GEORGETOWN-SCOTT COUNTY PLANNING COMMISSION

**AGENDA
JUNE 9, 2022
6:00 p.m.**

**PARKVIEW MEDICAL PLAZA
PRELIMINARY DEVELOPMENT PLANS**

**Staff Report to the Georgetown-Scott County Planning Commission
JUNE 9, 2022**

PRELIMINARY LANDSCAPING PLAN

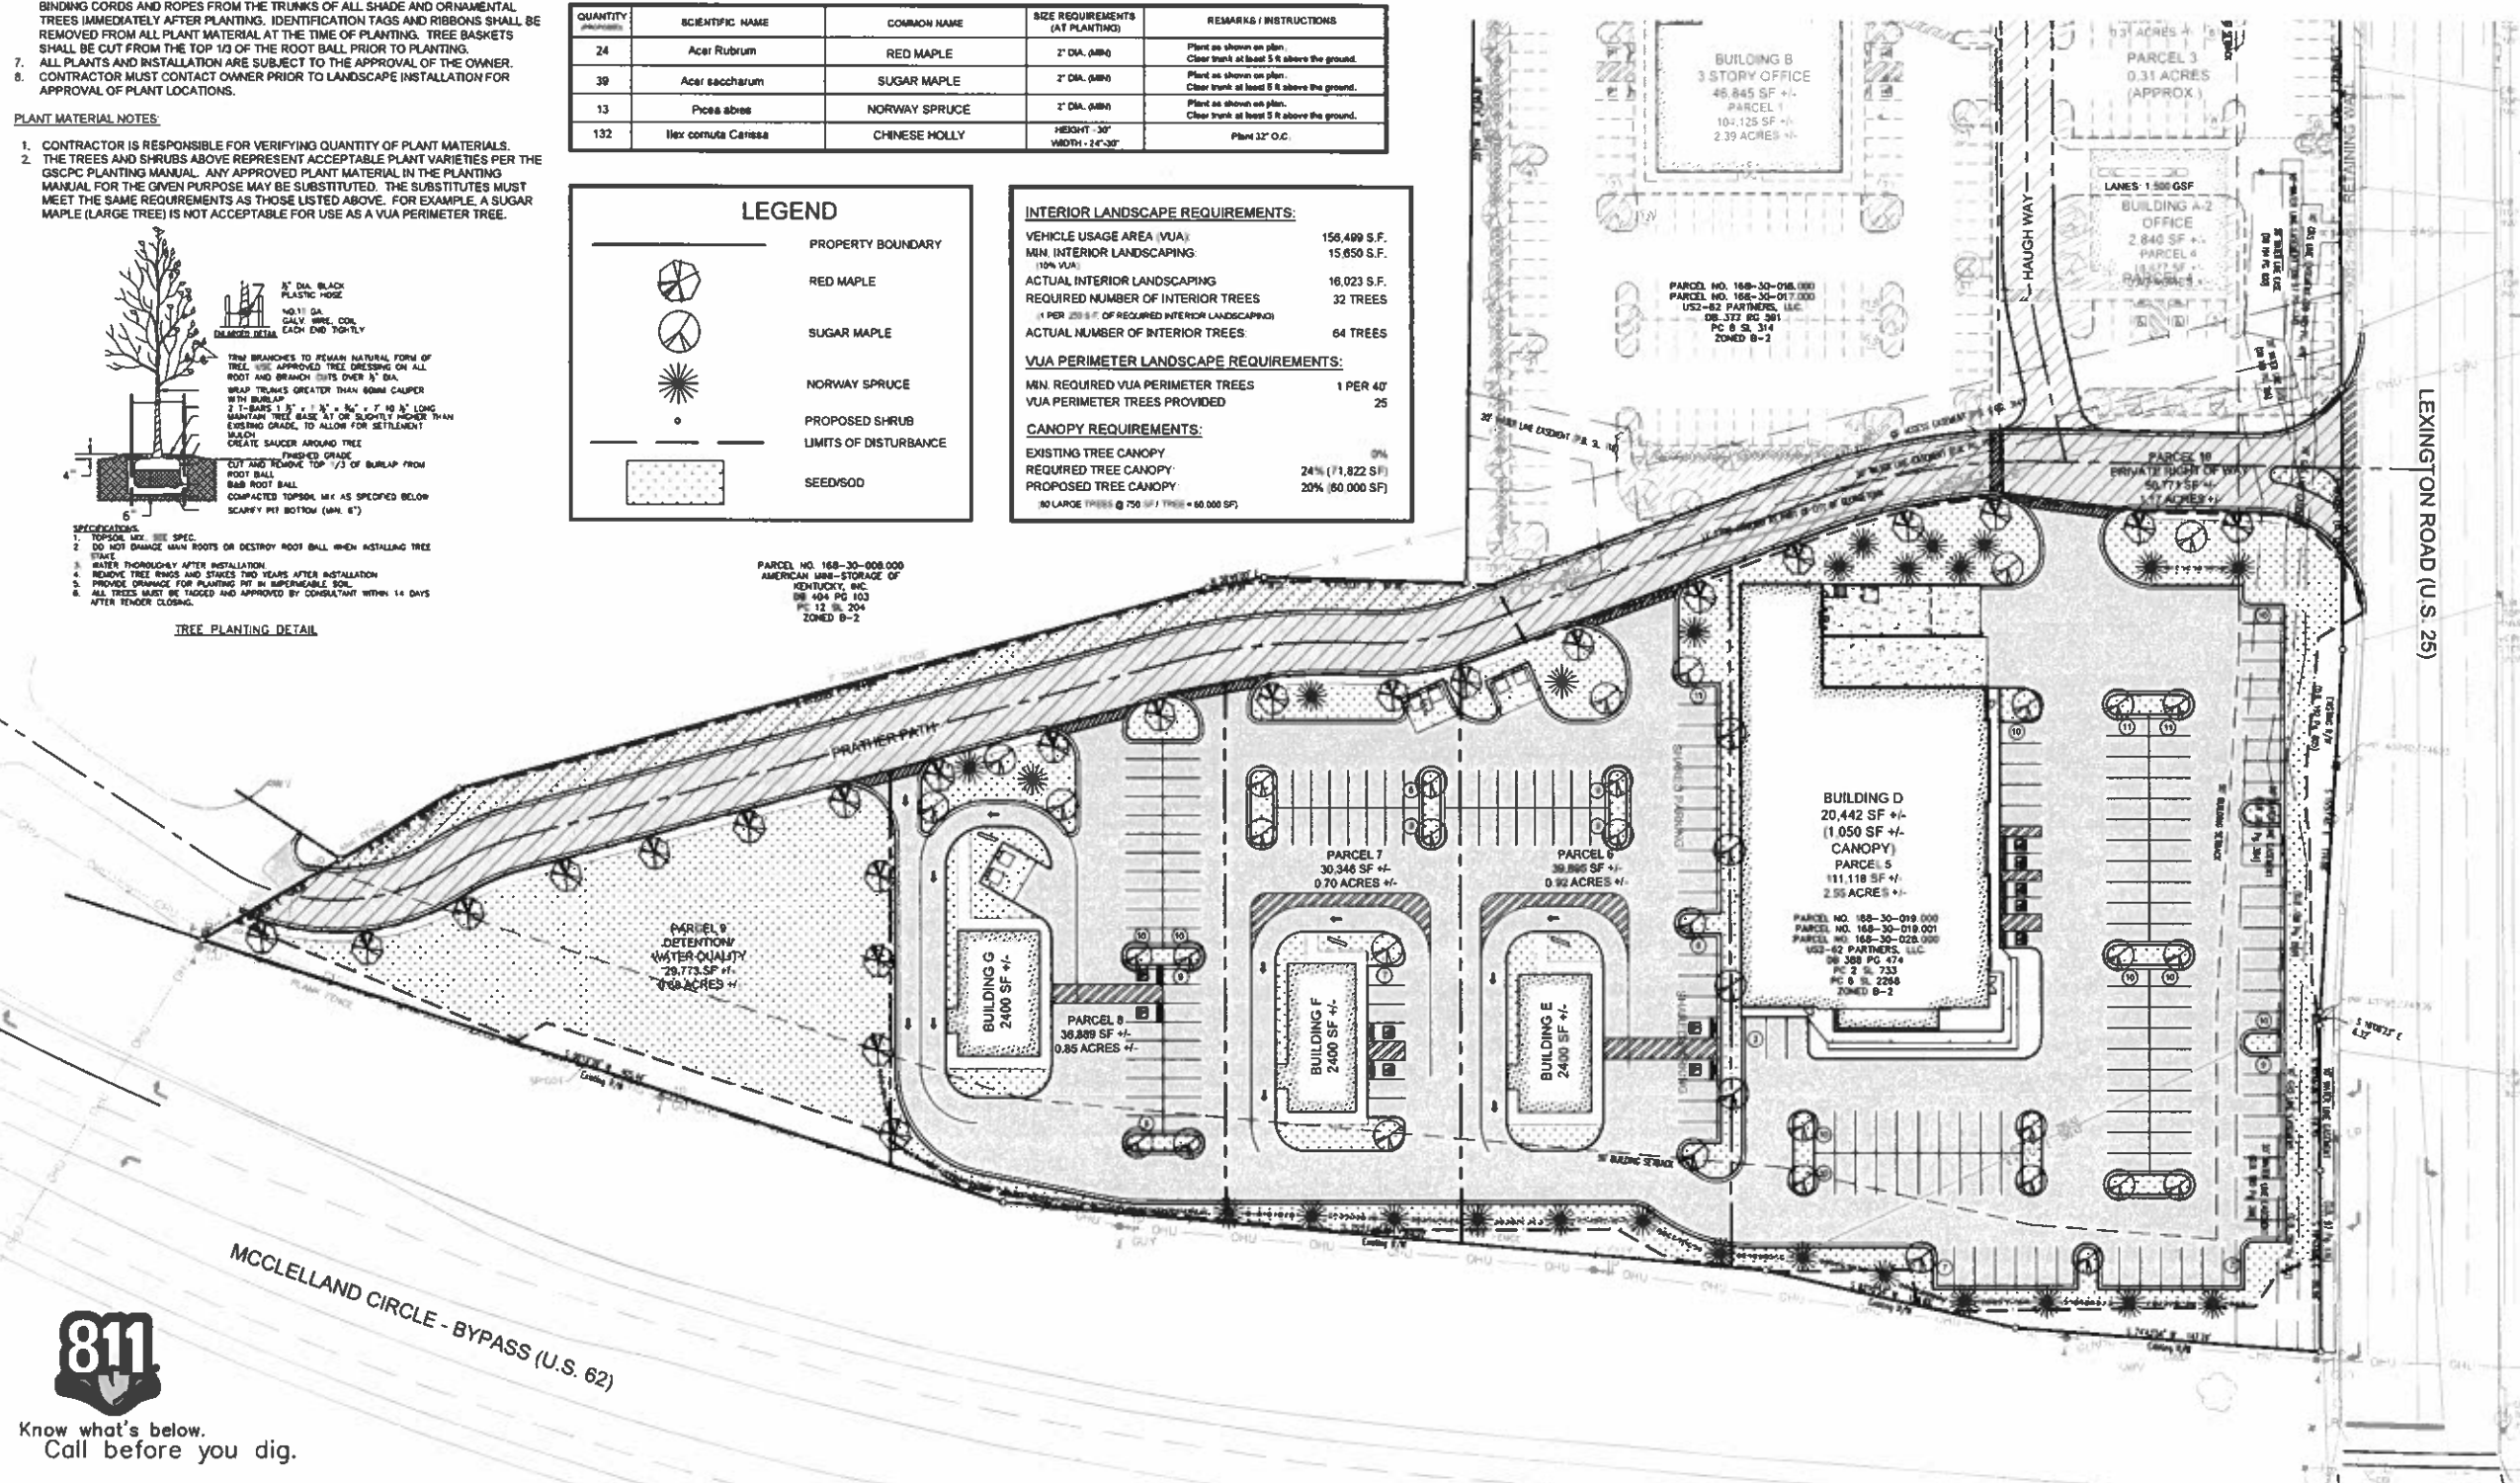
The Applicant is not proposing to preserve any existing trees on the site, so 24% canopy coverage will be required. The Preliminary Development Plan shows a proposed 20% canopy coverage. A request to reduce the amount of required coverage was not submitted to staff, so staff would expect the Final Development Plan to meet the canopy requirements. It is acceptable to staff for additional trees to be proposed in the stormwater detention area.

10. The Final Development Plan shall have a specie specific Landscaping Plan in compliance with the *Landscaping & Land Use Buffers Ordinance*. This shall include buffering along Lexington Road and the canopy requirements.
